# ASHRAE<sup>®</sup> STANDARD

## BACnet<sup>™</sup> - A Data Communication Protocol for Building Automation and Control Networks

The purpose of this addendum is to add a number of independent substantive changes to the BACnet standard. These modifications are the result of change proposals made pursuant to ASHRAE continuous maintenance procedures and of deliberations within Standing Standard Project Committee 135. The changes and their rationale are summarized below.

### 20.1.2.11 Format of the BACnet-Confirmed-Request-PDU

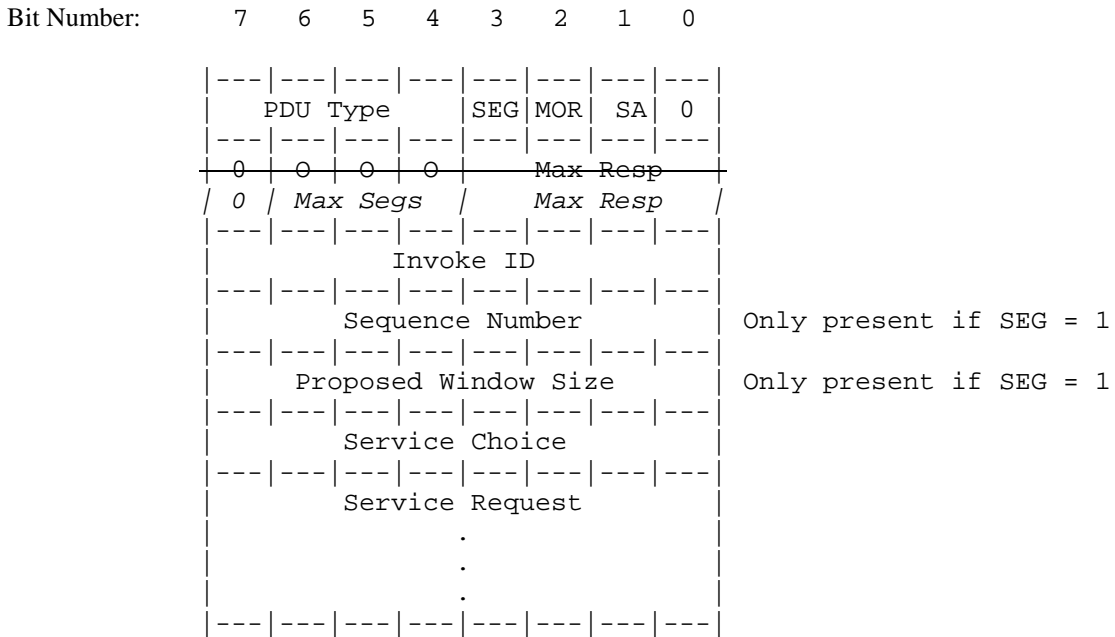
[Change 20.1.2.11, p. 325]

The format of the BACnet-Confirmed-Request-PDU is:

The PDU fields have the following values:

- PDU Type = 0 (BACnet-Confirmed-Service-Request-PDU)
- SEG = 0 (Unsegmented Request)
- = 1 (Segmented Request)
- MOR = 0 (No More Segments Follow)
- = 1 (More Segments Follow)
- SA = 0 (Segmented Response not accepted)
- = 1 (Segmented Response accepted)
- Max Segs = (0..7) (Number of response segments accepted per 20.1.2.4)
- Max Resp = (0..15) (Size of Maximum APDU accepted per 20.1.2.4 20.1.2.5)
- Invoke ID = (0..255)
- Sequence Number = (0..255) Only present if SEG = 1
- Proposed Window Size = (1..127) Only present if SEG = 1
- Service Choice = BACnetConfirmedServiceChoice
- Service Request = Variable Encoding per 20.2.

Bits shown in the diagram as '0' shall be set to zero. These bits are currently unused and are reserved by ASHRAE.
